Appl. No. 10/708,619  
Amdt. dated July 07, 2005  
Reply to Office action of April 20, 2005

Amendments to the Drawings:

Fig. 11

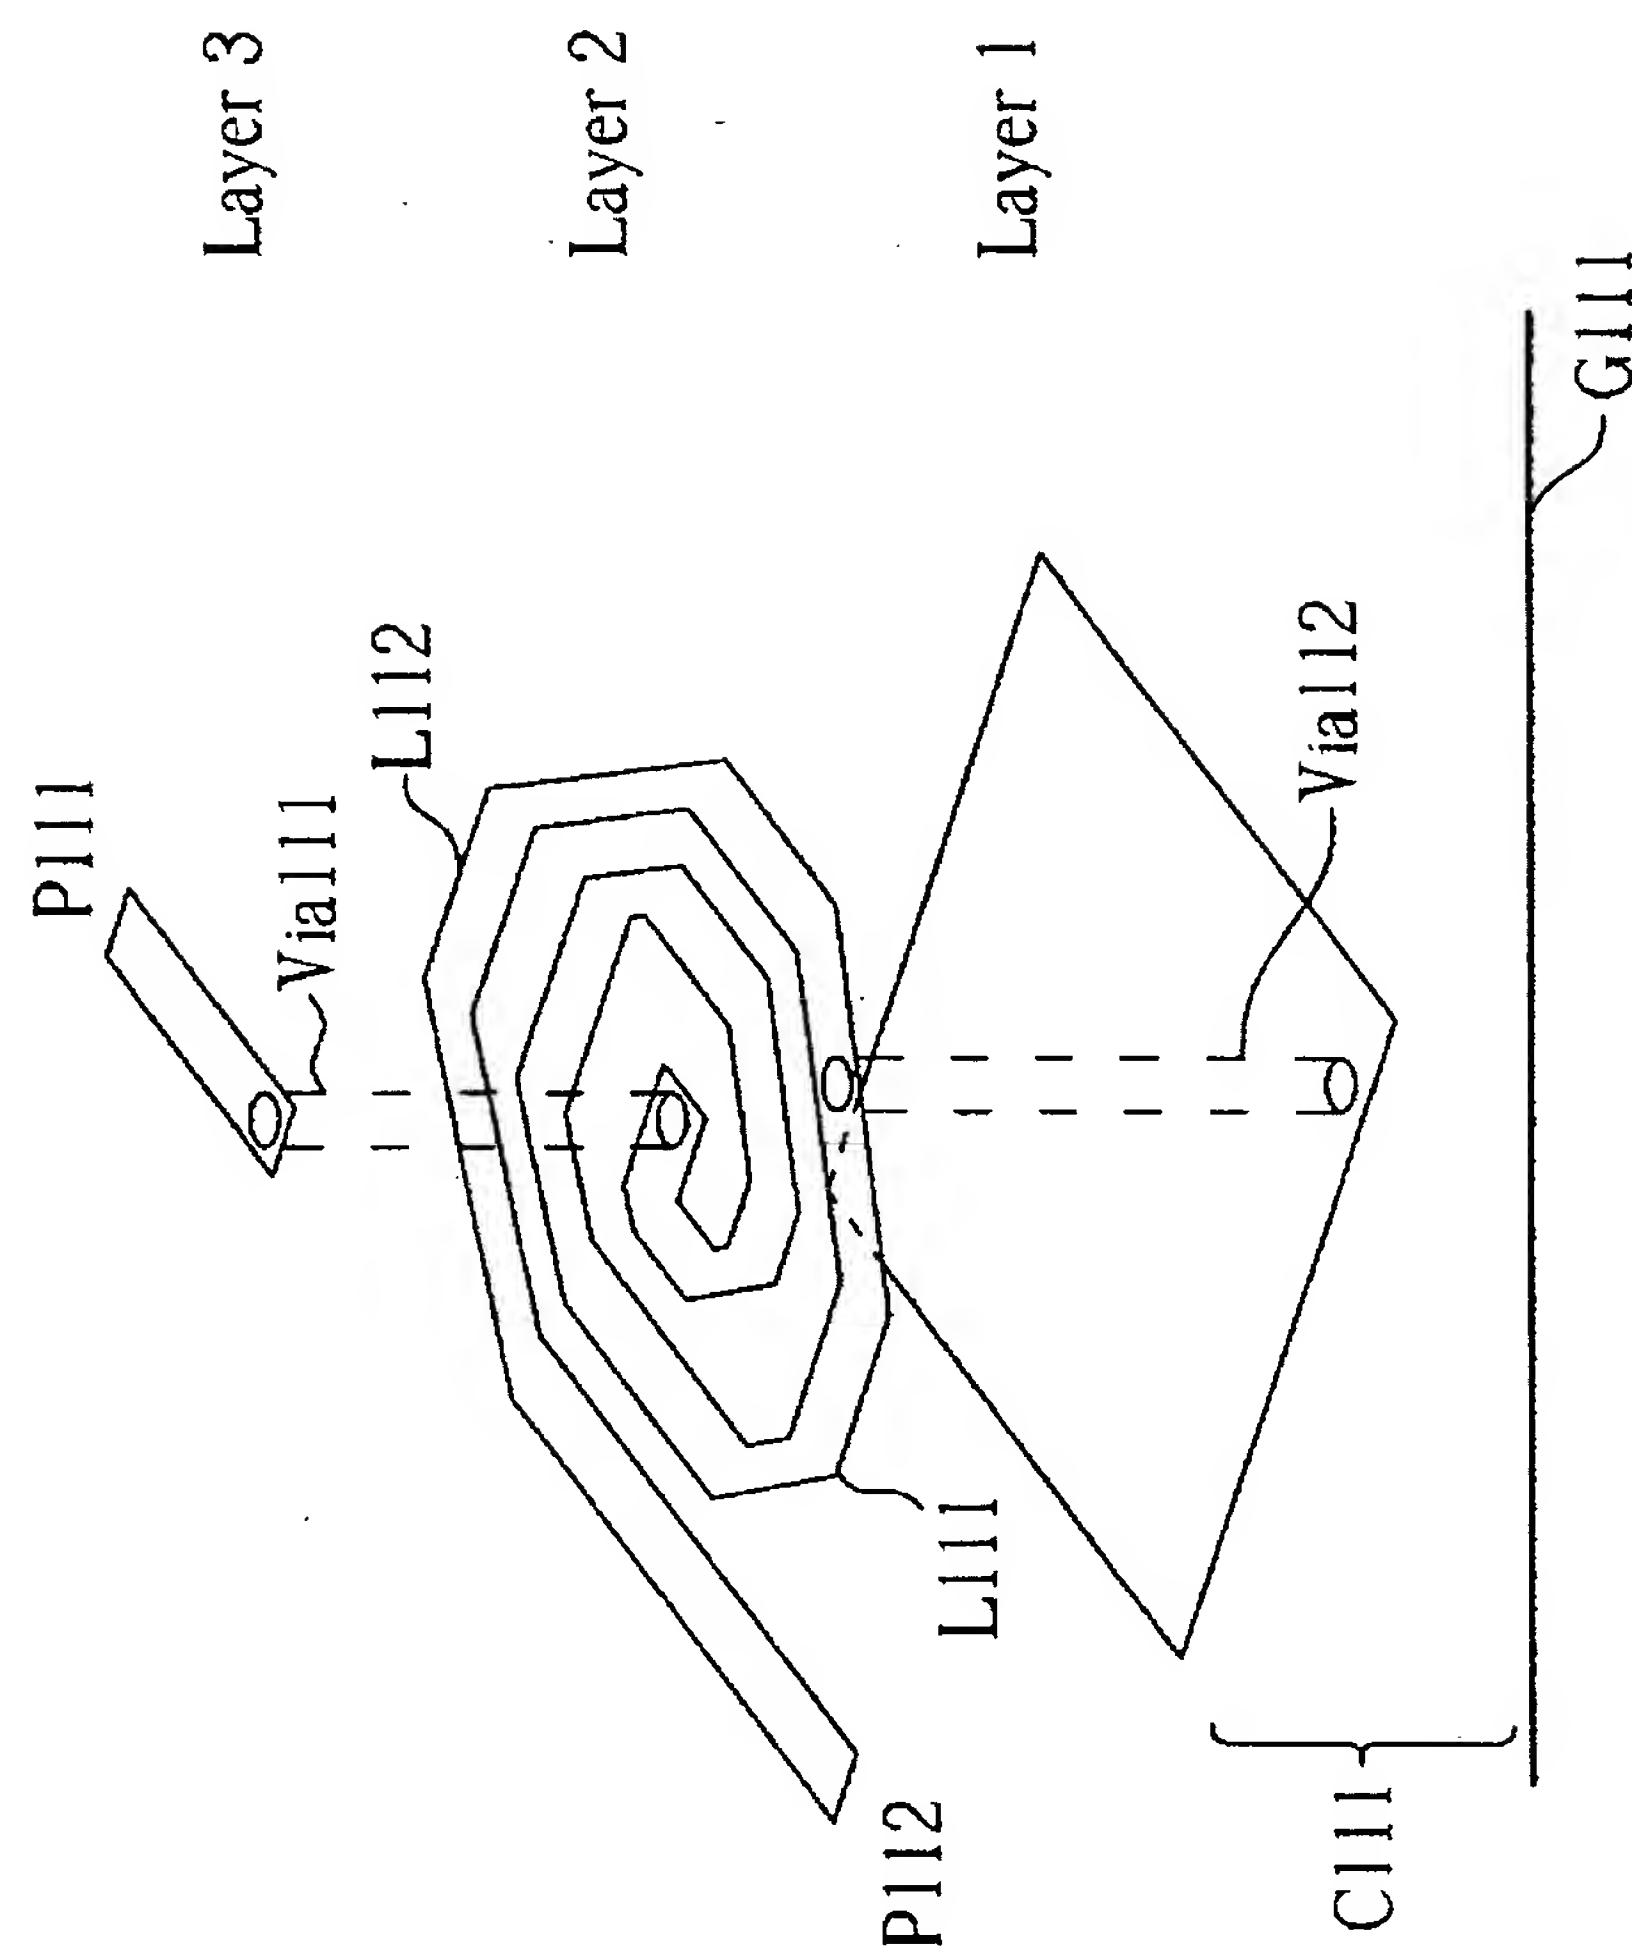
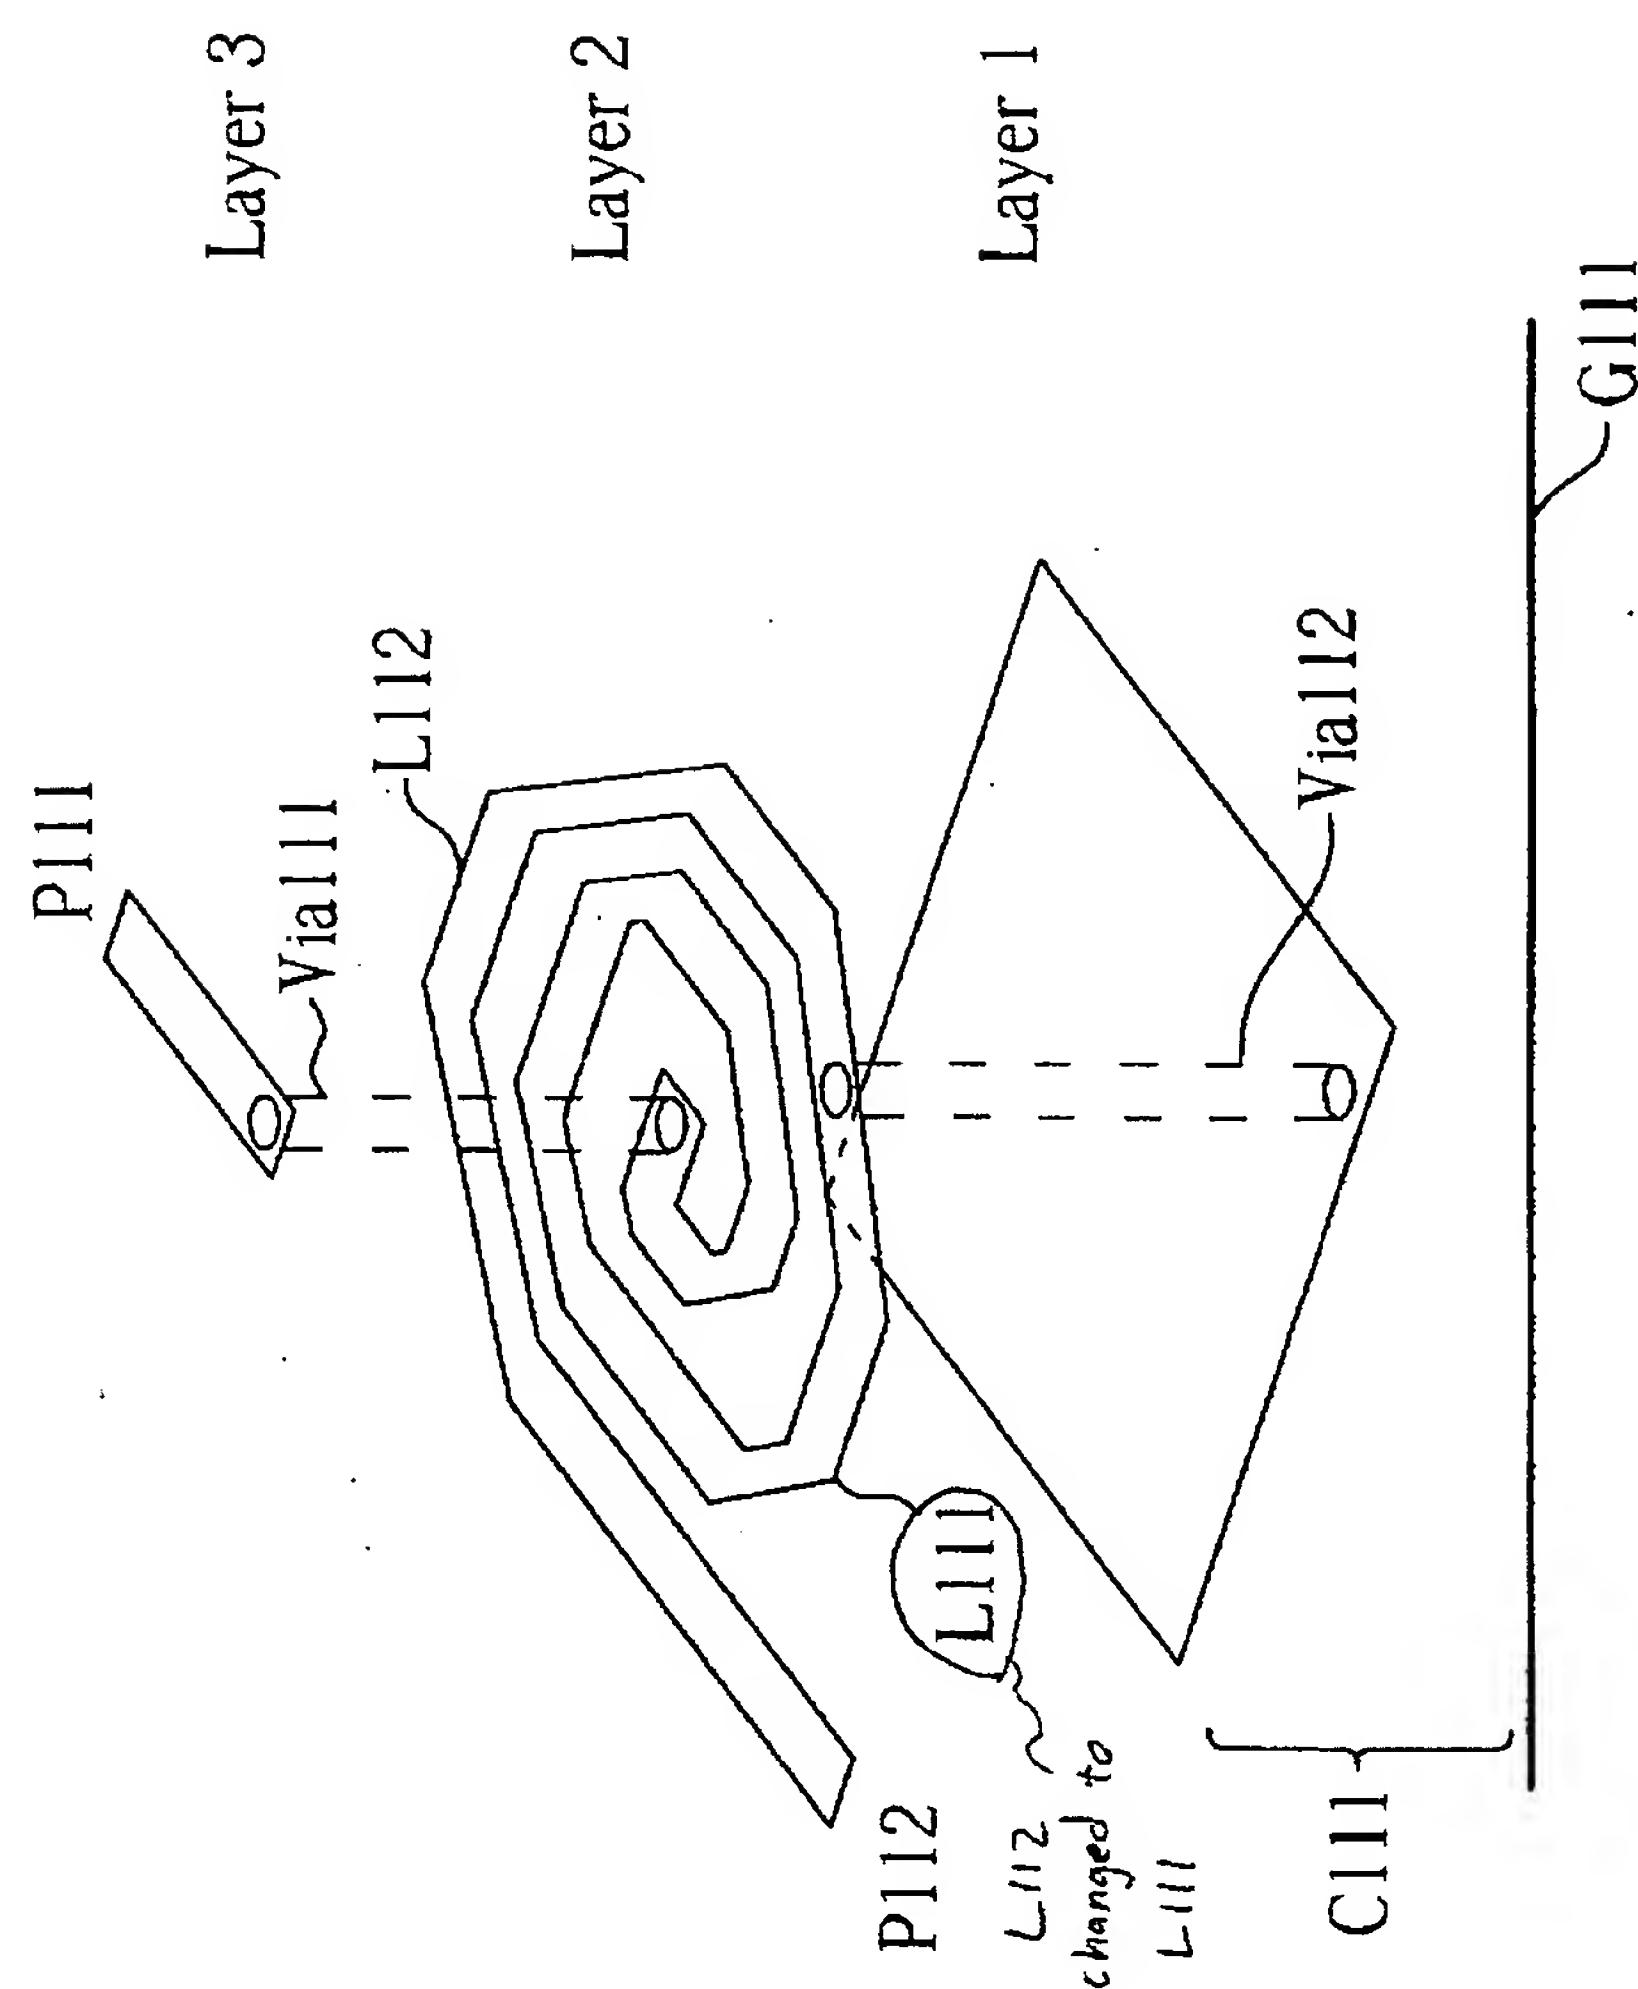
Figures 11 and 12 have been amended to include the following reference signs: 111 and 121. These changes correspond with the specification, and no new matter is added.
